Re: Preliminary/Final Water Quality Plan Briarcliff  
Meadows South  
SM File #: 210363  
Tract Size/Zone: 9.41 Ac/RE-1  
Tax Plate: KS-122 and 342  
Montg. Co. Grid: 31K01  
Watershed: Upper Paint Branch

Re: Briarcliff Meadows South, 1-04036  
MHG Project No. 97.355.22

SUBJECT: Preliminary Plan No. 1-04036  
Briarcliff Meadows South  
Rowland Lane/Peach Orchard Road  
Cloverly Policy Area

RE: Preliminary Plan #1-04036  
Briarcliff Meadows South

Attachment 2

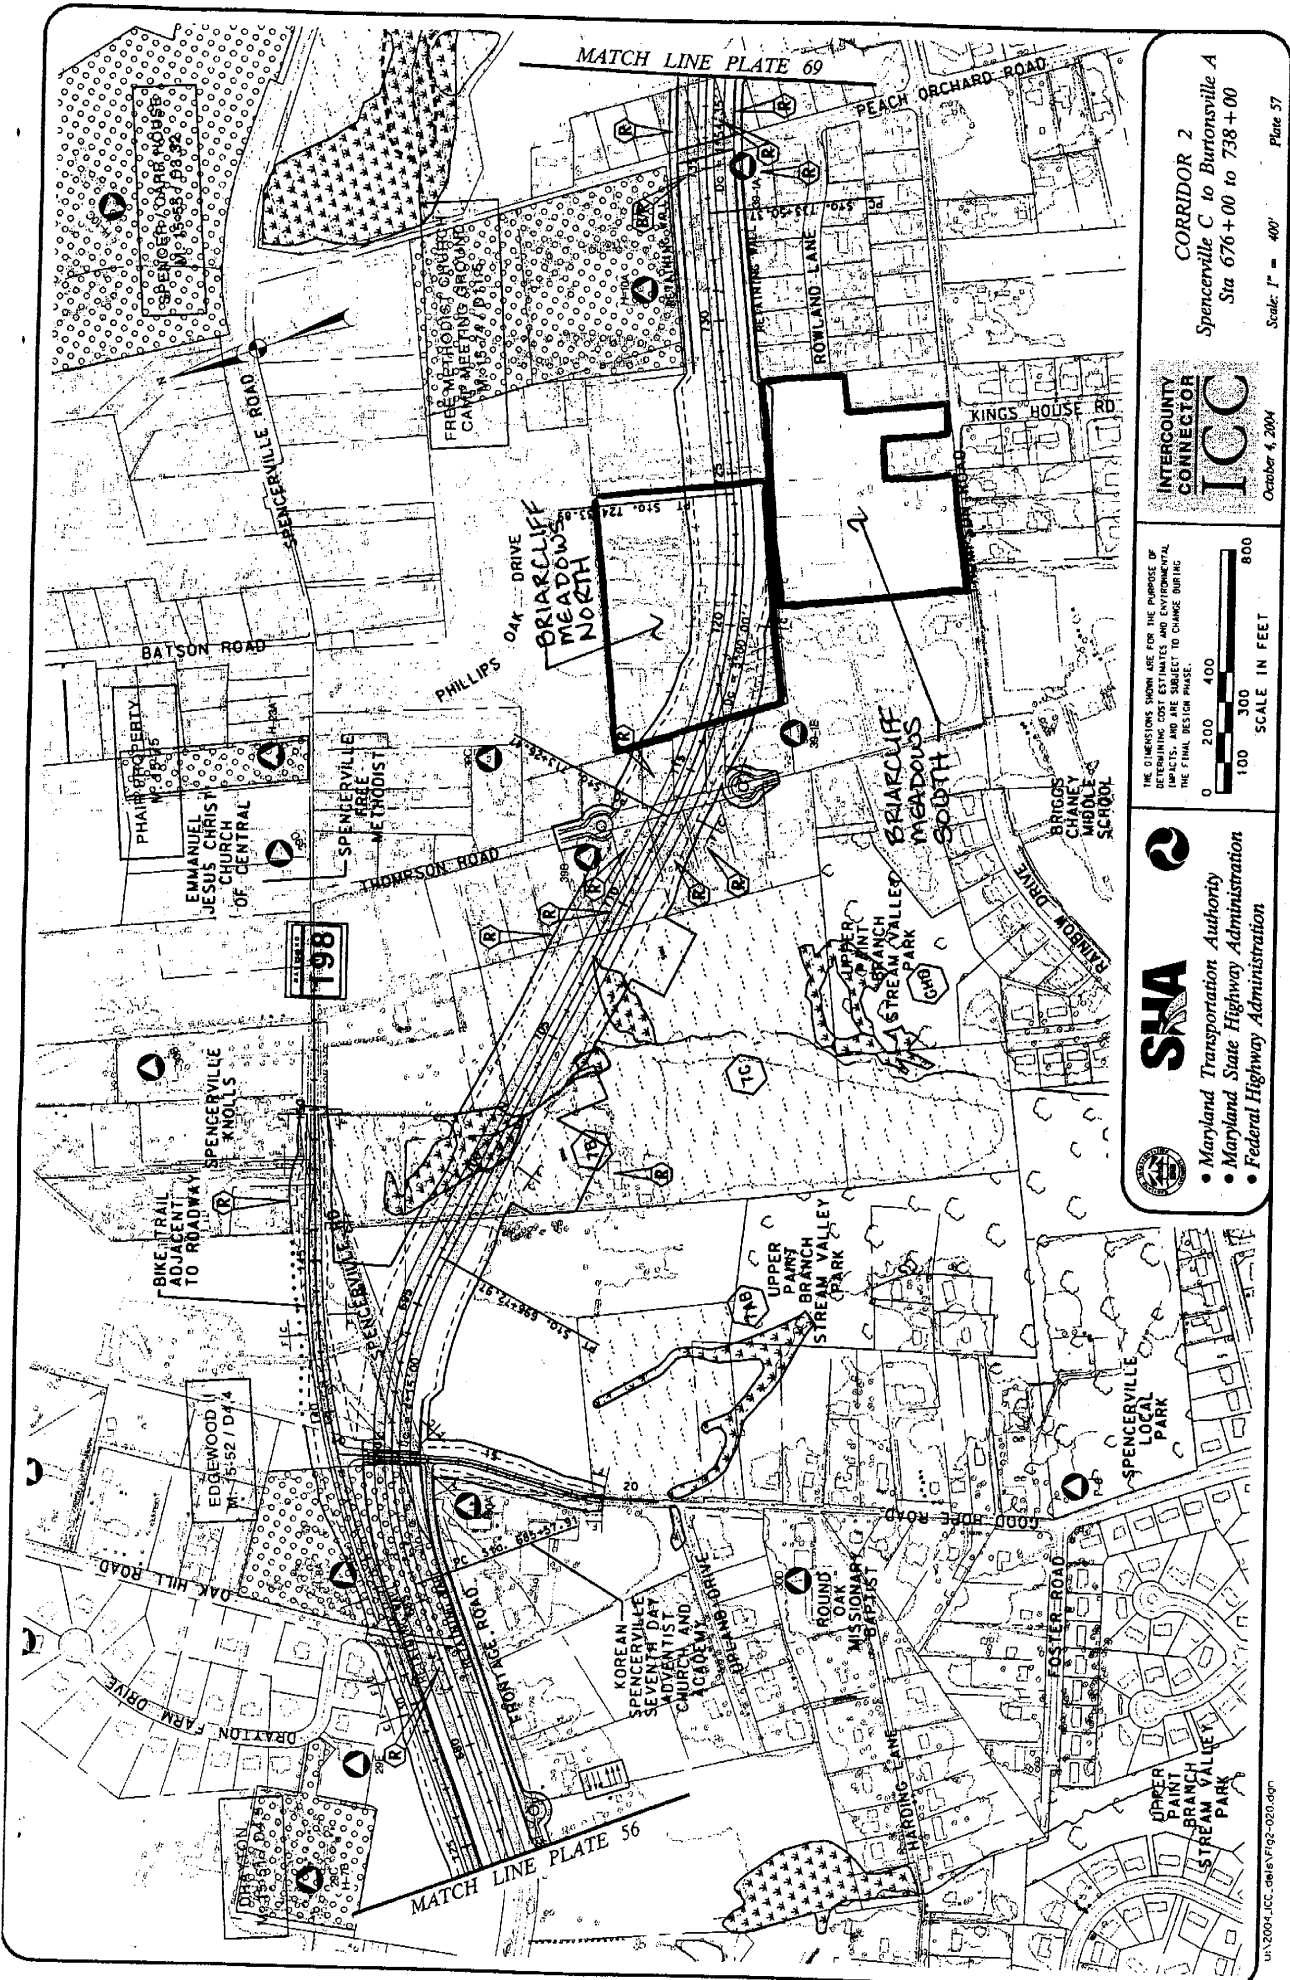
The ICC planning process has concurrence on two alternative alignments, selected through the Alternatives Retained for Detailed Study process, called Corridor 1 and Corridor 2. Corridor 1 is the southern alignment that generally follows the alignment incorporated in the area master plans for the ICC, and Corridor 2 is the alignment to the north that is not represented in any area master plans. Of the above two alternative roadway alignments, based on the most current information provided by the SHA, the Corridor 2 alignment would physically impact the proposed Briarcliff Meadows South development as shown on Attachment 1 and on Attachment 2.
